# Springbank Off-stream Reservoir Project:

climate change, hydrogeology, geochemistry & water quality

Jon Fennell, M.Sc., Ph.D., P.Geol.

On behalf of the Springbank Concerned Landowners Group

Exhibit 110, pdf pg. 78-80

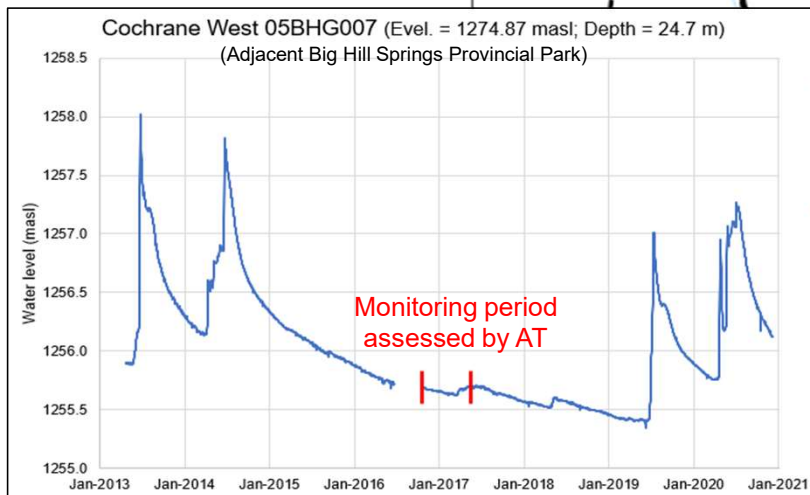
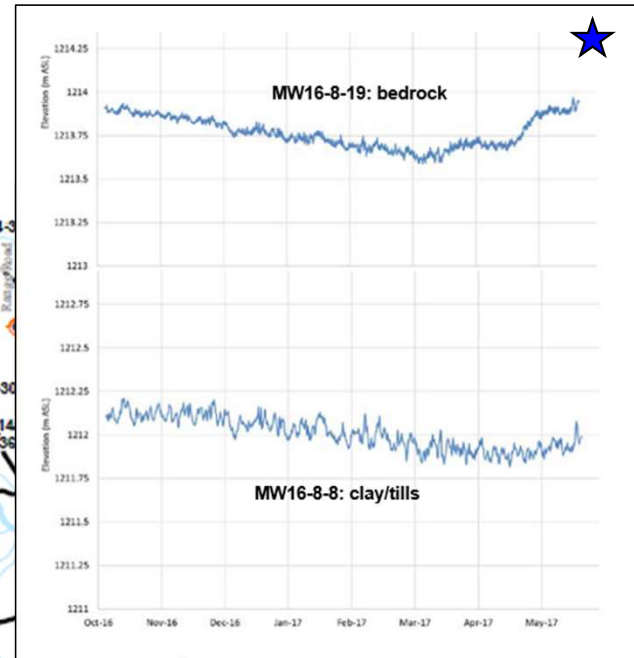
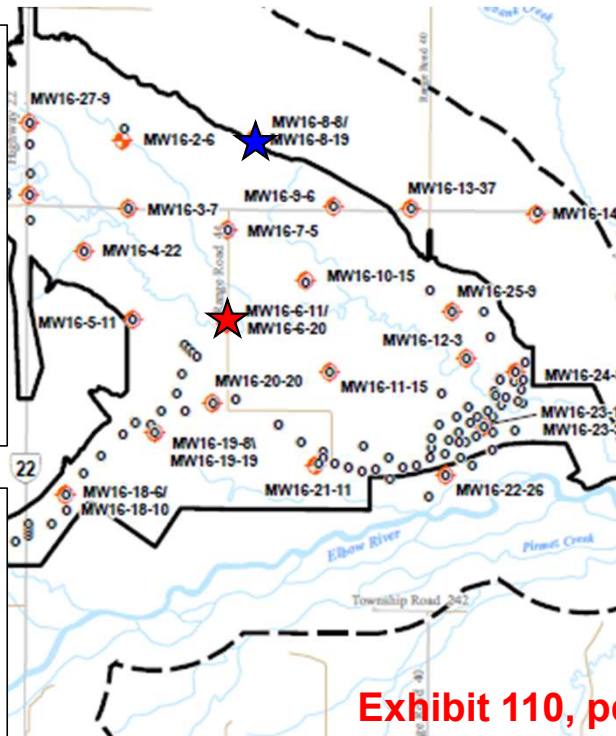
Assumption that flow gradients are consistently upward from the bedrock to clay/tills (as stated in Exhibit 327 pdf pg. 46) is challenged by lack of monitoring record. Possibility of long-term sustained gradient reversal exists.

From Exhibit 178, pdf pg. 408 & 409

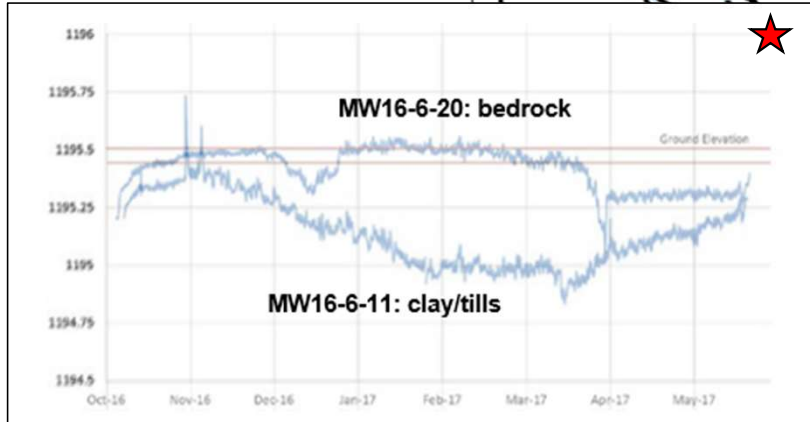
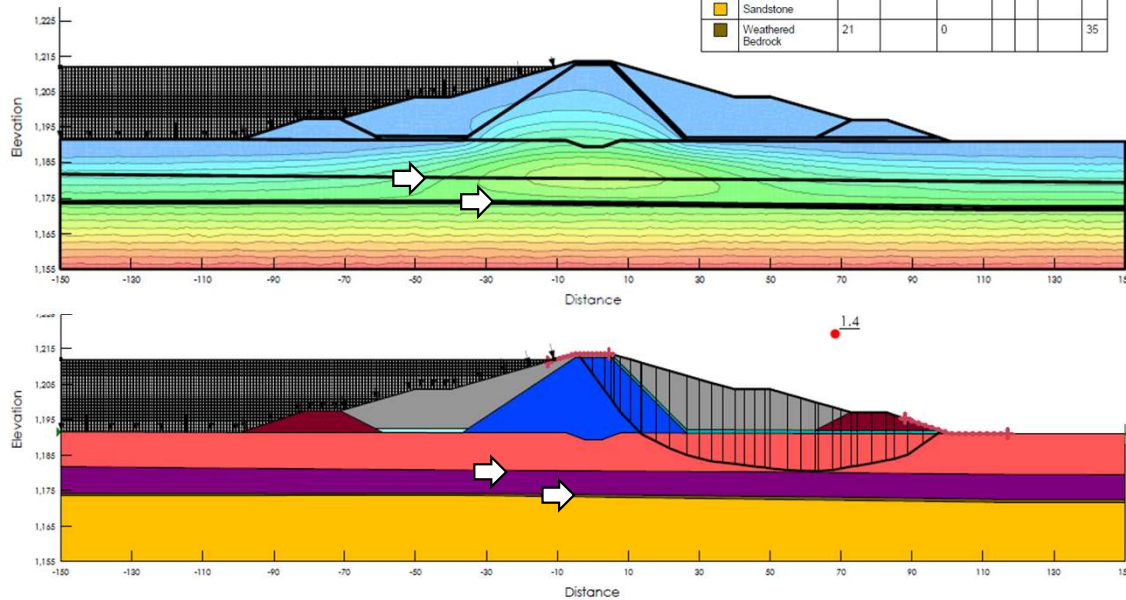
Increase in subsurface porewater pressures due to external loading (*dam materials + water*) is a concern with respect to possible shear-slip at interface between soil/rock or in weak soil intervals (*i.e. montmorillonite-rich layers*).

on groundwater if hydraulic conductivity values were increased by a factor of 1,000 above the best estimates previously noted. In addition, effects on pore pressures were in fact examined under the most conservative scenario, where the complete external loading due the 'weight of the water' impounded in the reservoir was applied directly to the underlying bedrock, assuming that none of this external load would be borne by the overlying clays/tills. Further conservatism was added by conducting these simulations under steady state conditions, representing the scenario where water in the reservoir is held indefinitely.

Figure 3-30 Diagram of Monitoring Well Chemistry

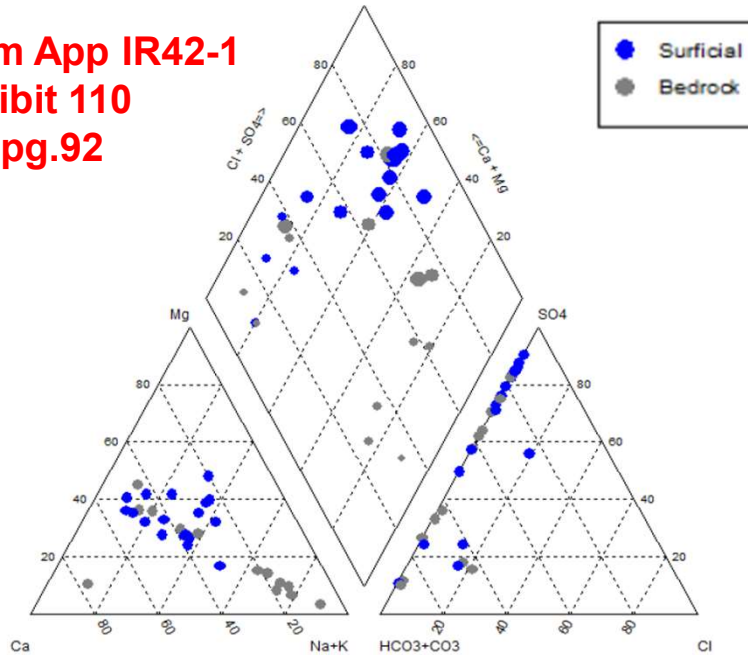
Similarity in major ion composition for groundwater in clay/tills and bedrock intervals provides evidence of hydraulic connectivity.

Statement that no difference exists in TDS values (*Exhibit 327 pdf pg. 46 para. 1*) for clay/till and bedrock waters is unsubstantiated based on statistical testing.
